Skyline Mine

RE: Swens Canyon Ventilation Facility (SCVF), Canyon Fuel Company, LLC, Skyline Mine,
C/007/0005, Task ID 4777

Swens Canyon Ventilation Facility
Significant Revision – Task ID 4777
Administrative Completeness Response

Figure 4.9-D
 Swens Canyon Ventilation Facility
 Vent/Escape Shaft

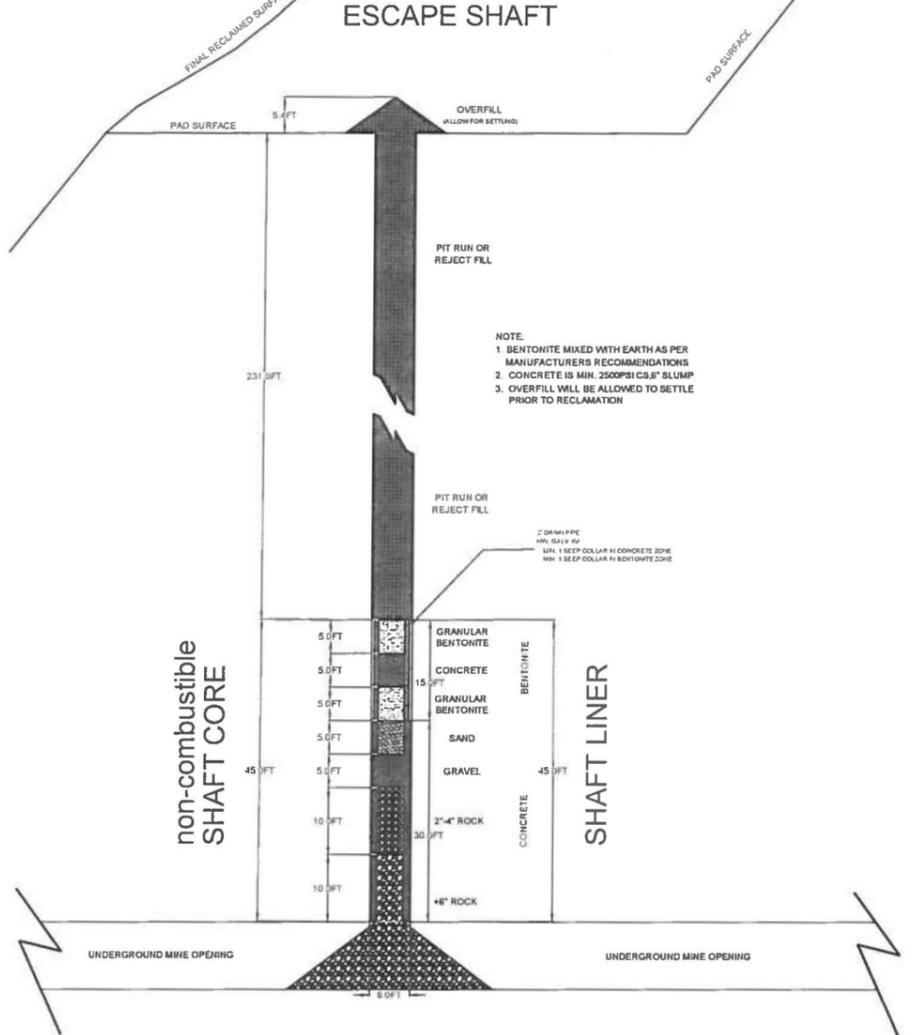
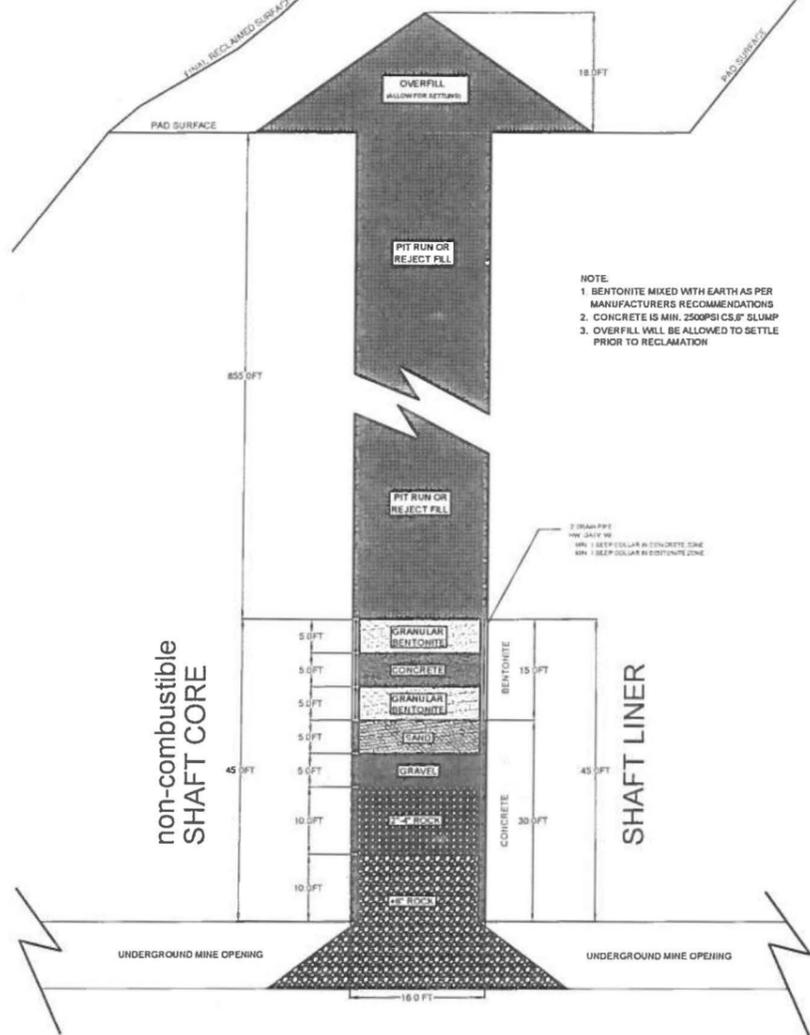
Shafts in the Swens Canyon Ventilation Facility (SCVF) area will be abandoned in the same fashion. Figure 4.9-D illustrates the abandonment. The notable differences are the depths and diameter of the shafts. Cuttings from the drilling of the shafts will be used in the backfill at reclamation.
